TECHNICAL SERVICE BULLETIN

TSB 2016-1003 Level: 2

Topic	“Update ManTooth” feature in ManTooth Android App is intended only for use with ManTooth-PT models 67001, 67002 and 67003. Using this feature with ManTooth-V and ManTooth-PTV 67020, 67021 and 67023 models causes these units to malfunction. The “Update ManTooth” feature is to bring the first generation ManTooth units up to second generation ManTooth <u>connectivity only</u> . This feature does <u>not</u> give the unit total PTV capability.
Affected Units	All ManTooth-V & ManTooth-PTV units; models 67020, 67021 and 67023
Resolution	An app update is in process to restrict users from being able to “Update ManTooth” on ManTooth-V & ManTooth-PTV models

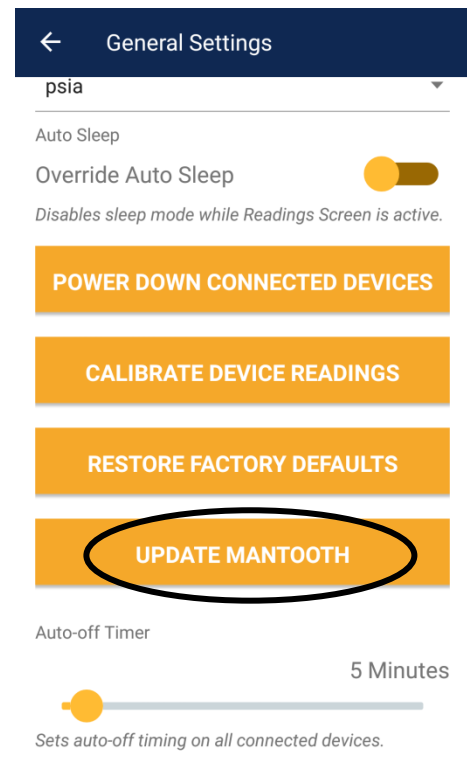
The “Update ManTooth” feature, accessible in the General Settings of the Android-version of the ManTooth 2.0 app, was designed to allow users of ManTooth-PT modules to update the Bluetooth radio settings in their ManTooth-PT modules. The “Update ManTooth” feature is to bring the first generation ManTooth units up to second generation ManTooth connectivity capability only. This feature improves the Bluetooth connectivity and the overall Bluetooth connection process but does **not** give the unit total PTV capability. This feature is not intended to be utilized with ManTooth-V and ManTooth-PTV models, as the radio settings in these modules are already up-to-date. However, if a ManTooth-V or ManTooth-PTV user utilizes the “Update ManTooth” feature, it will cause the updated device(s) to malfunction.

Do not apply the “Update ManTooth” feature to any ManTooth-V or ManTooth-PTV modules. These models already have the updated radio settings. We are in the process of an app update that will not allow users to select these modules when applying the “Update ManTooth” feature (restricted only to ManTooth-PT modules with serial numbers starting with the letters “YJPT”). Please check for app updates and keep the ManTooth app up-to-date on your devices.

If the “Update ManTooth” feature has been applied to your ManTooth-V or ManTooth-PTV modules, please contact customer service to make arrangements for module reprogramming.
